Tintenbar to Ewingsdale

Upgrading the Pacific Highway

Environmental Assessment
Submissions Report and
Preferred Project Report

May 2009

Figure 4.1e Preferred project

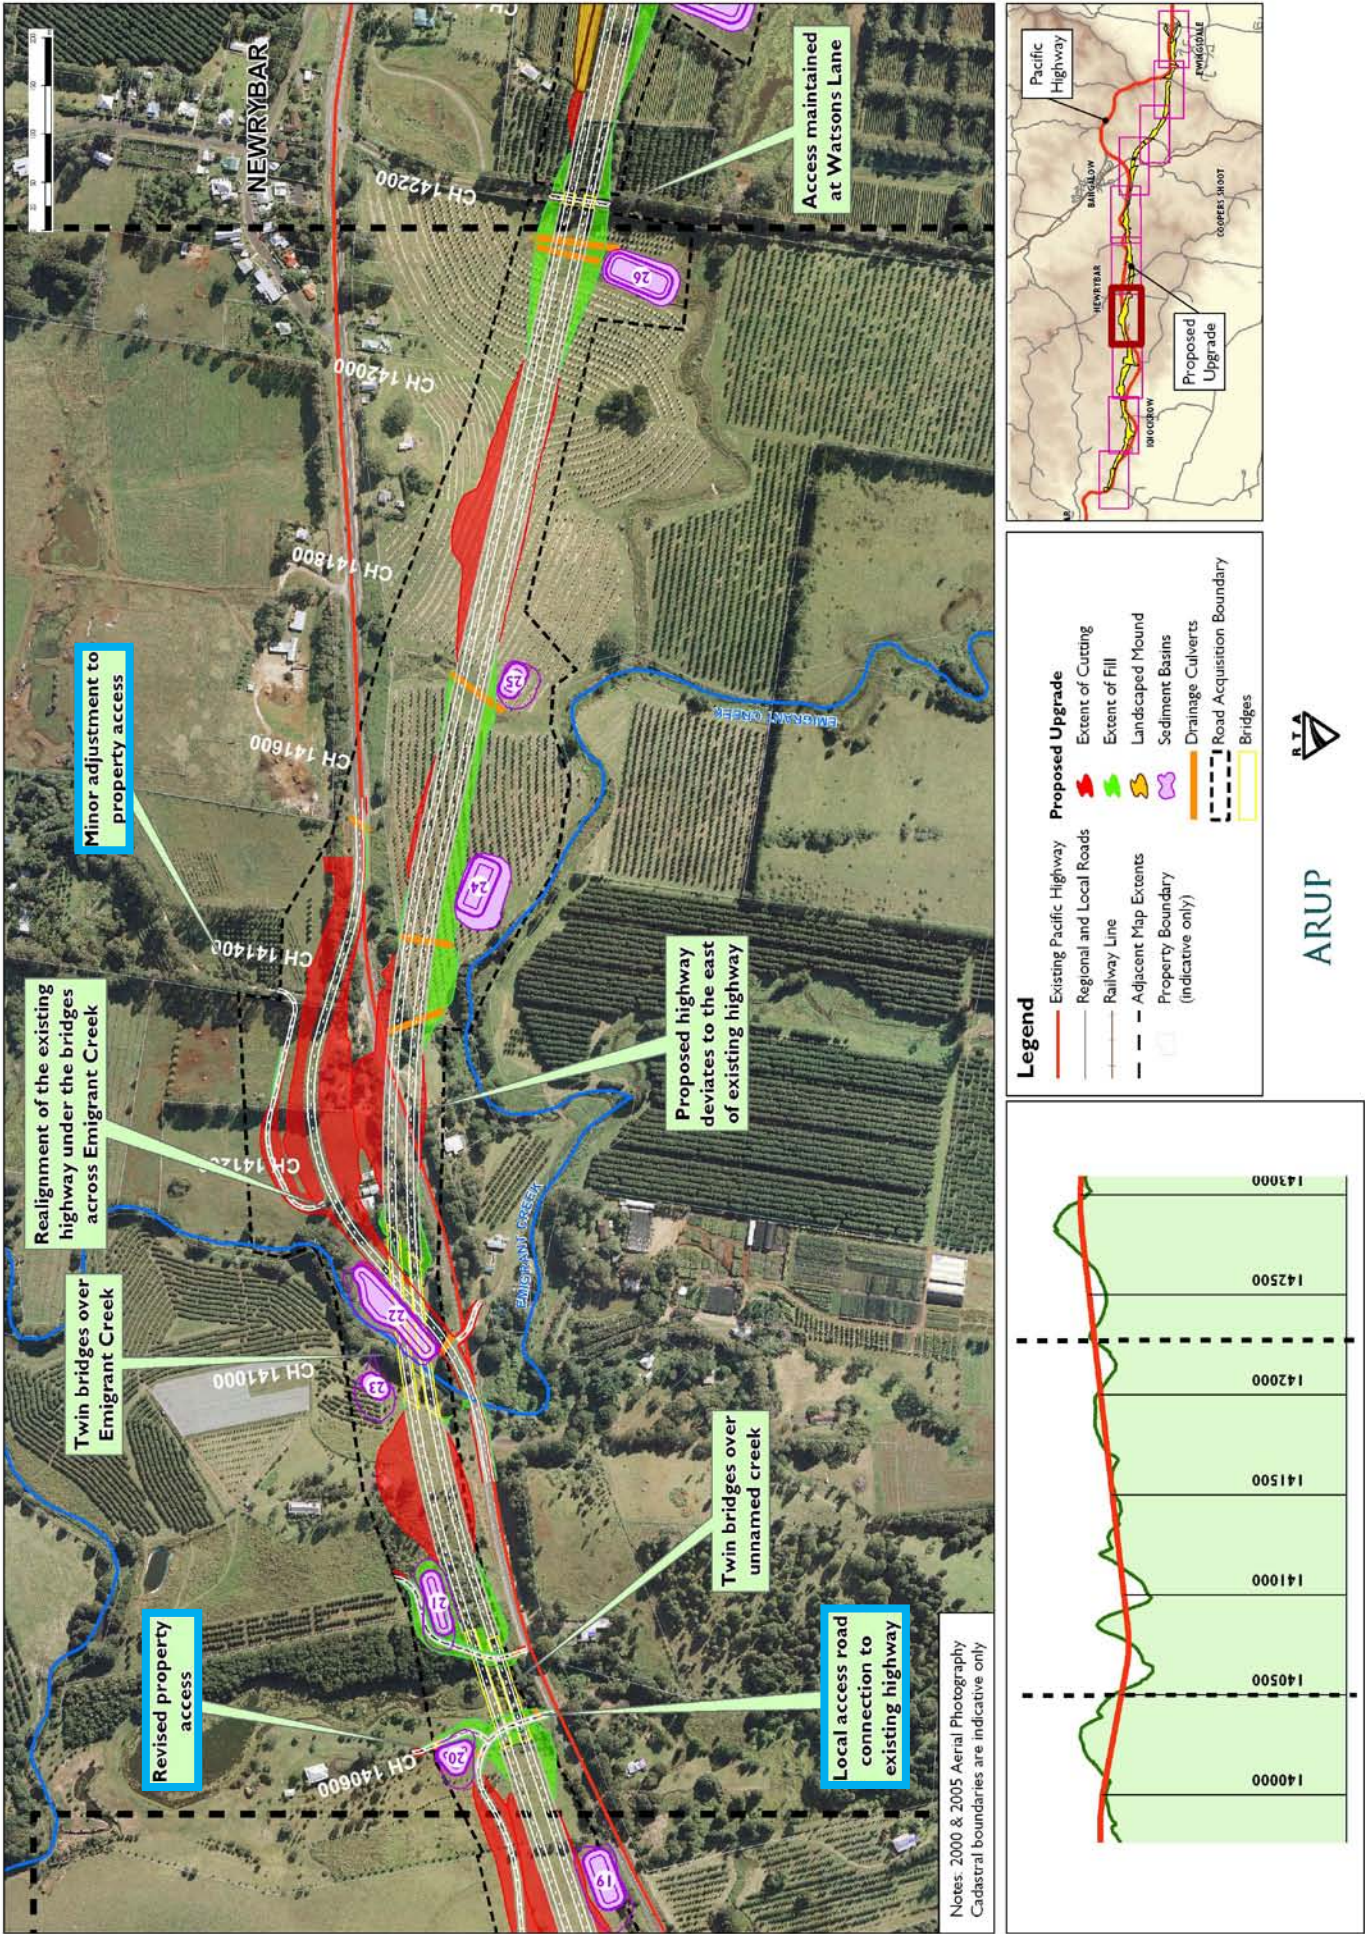
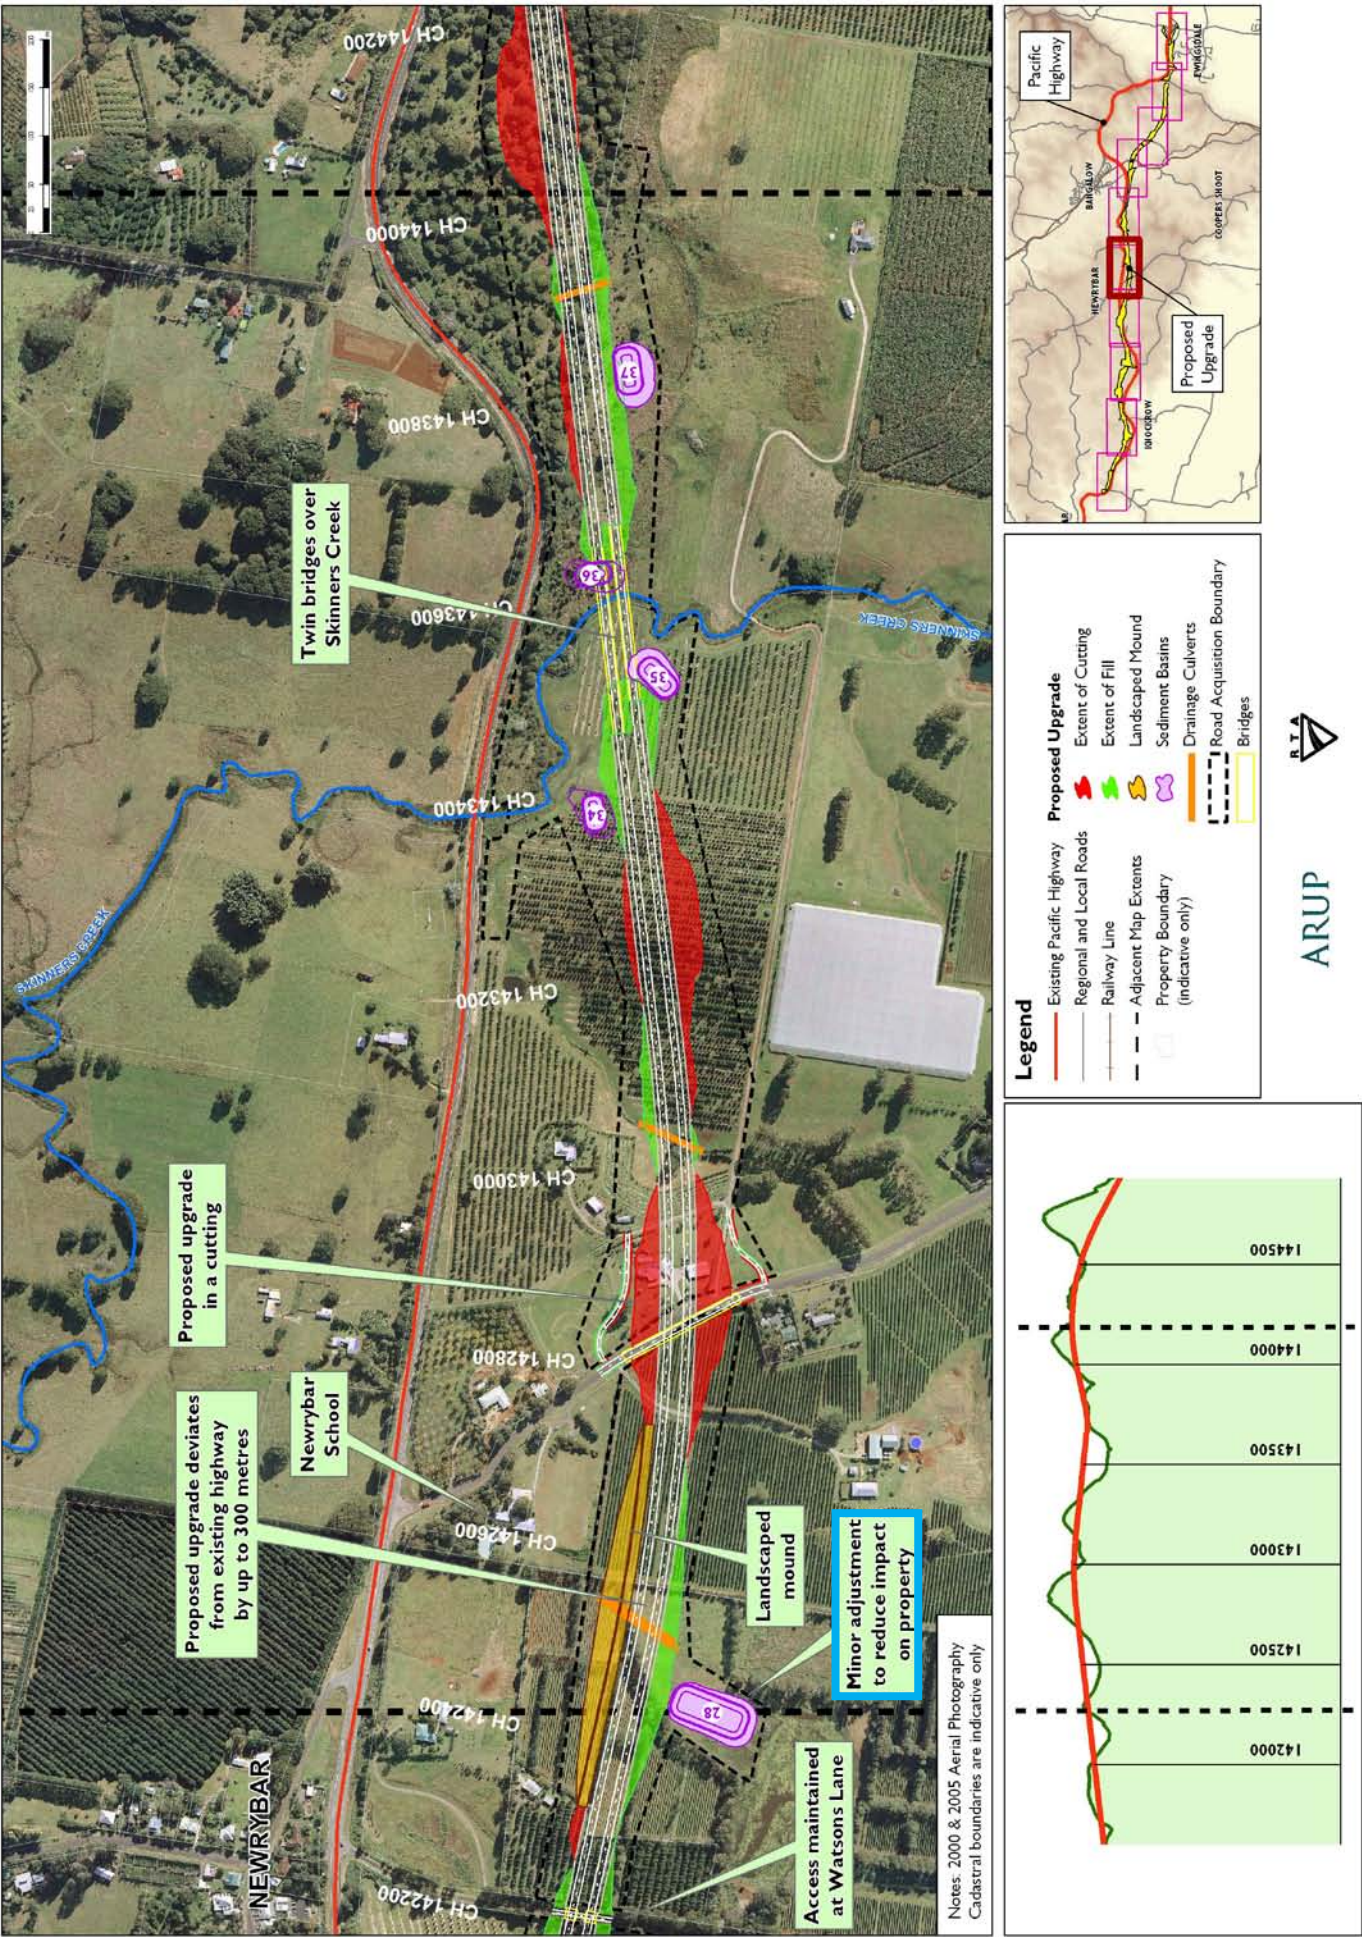
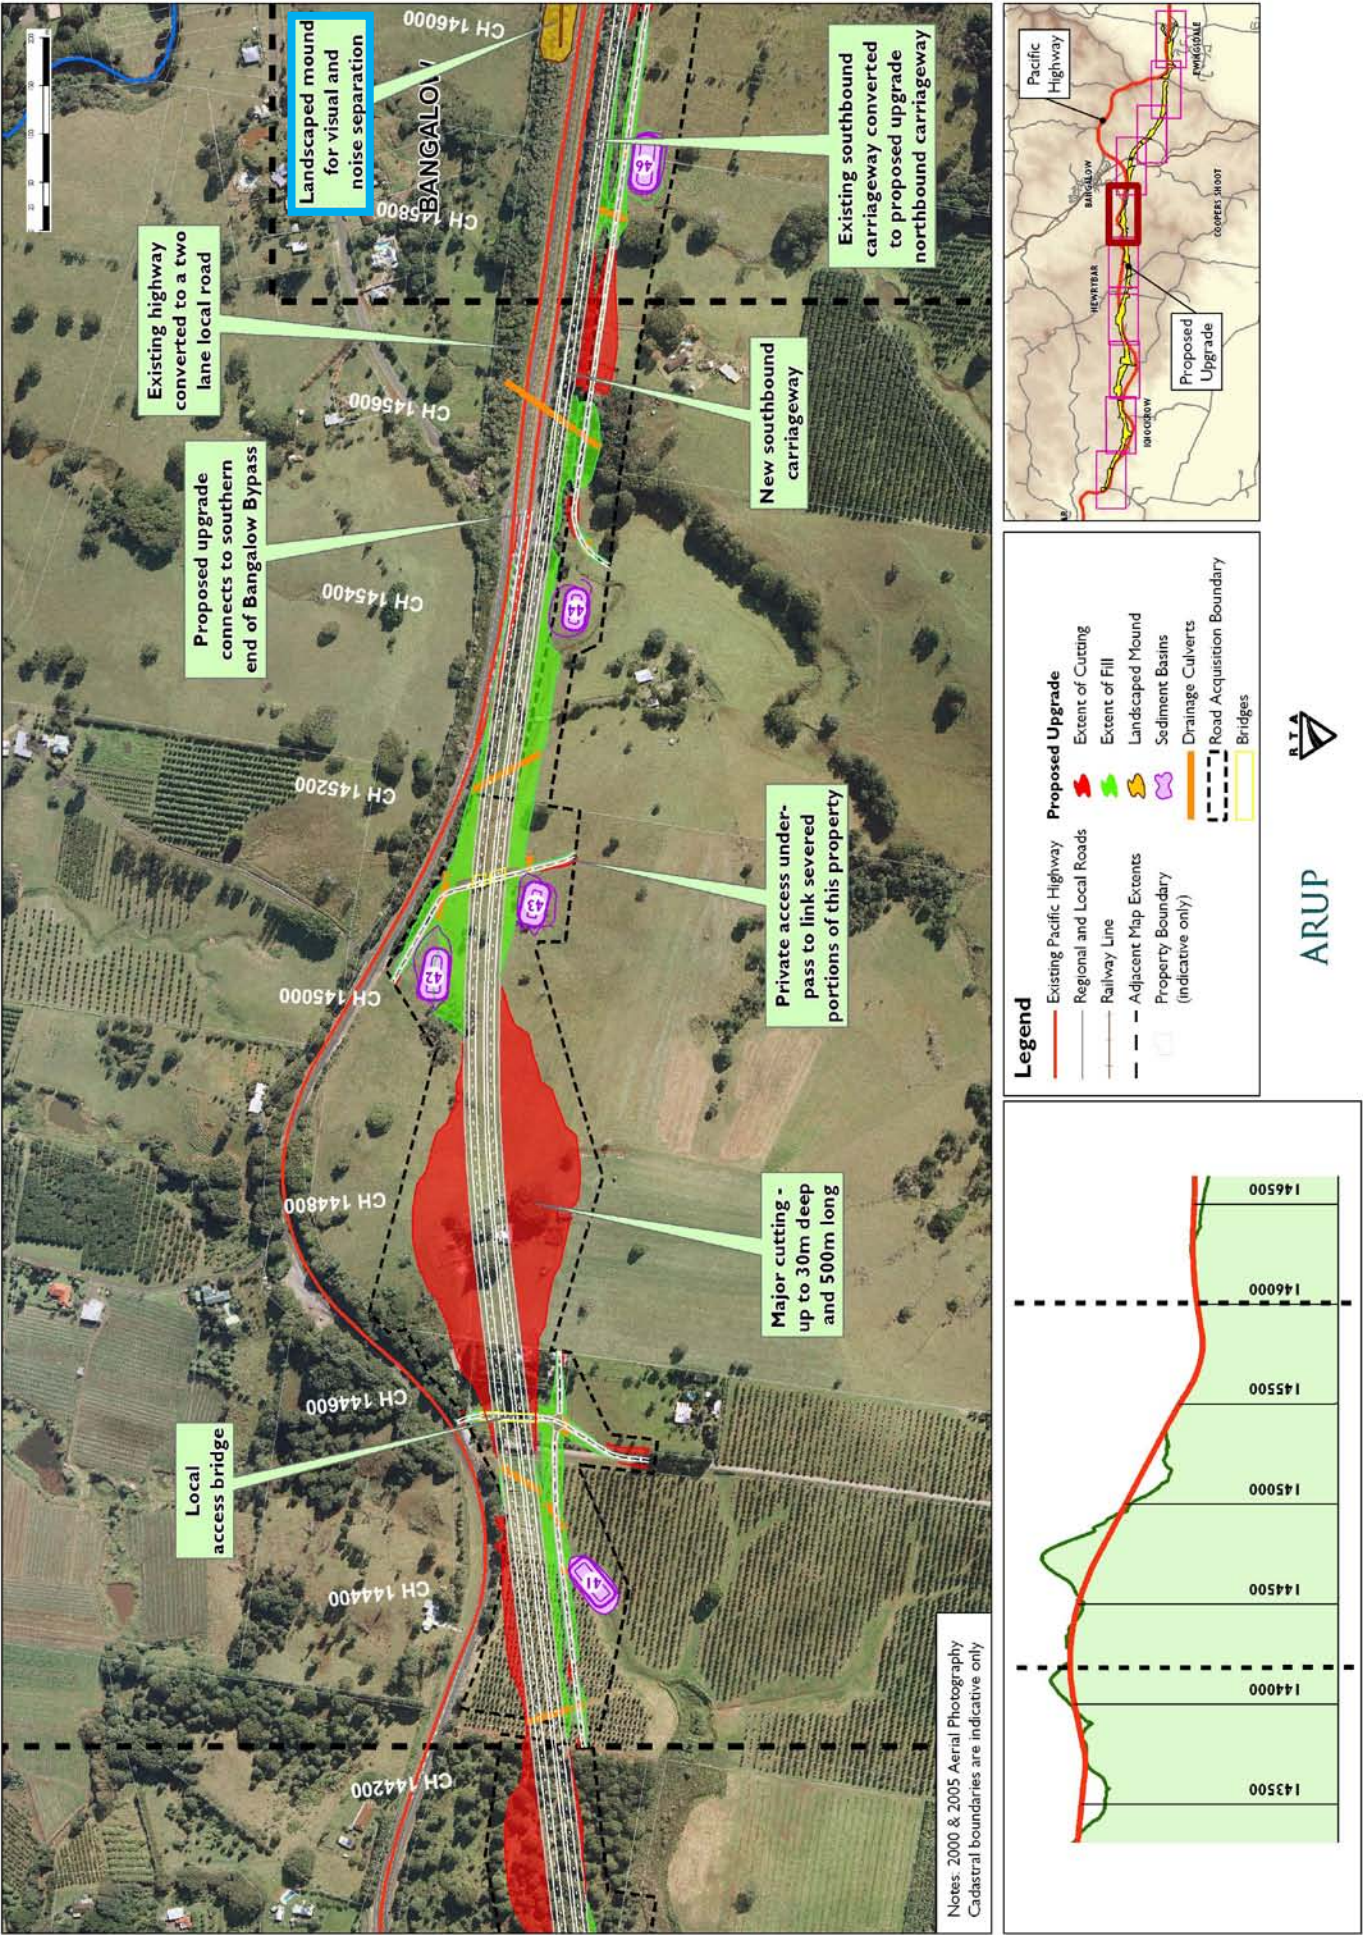
- > Concern over increased traffic on local roads
- > Concern over potential increased noise impacts.
- > Concern over visual and light spill impacts.
- > Questioning of the justification of the interchange in light of the projected level of use.

After further detailed consideration, the RTA has determined that the Ivy Lane interchange be removed from the proposed upgrade. The removal of the interchange is discussed in detail in Section 4.1 as part of the preferred project report.

As well as the interchange itself, the underpass at Ivy Lane would also be removed from the proposal and the local access road arrangements on the western side of the upgrade would be amended to provide access to the properties on that side. The altered configuration is shown in figure 4.1c.
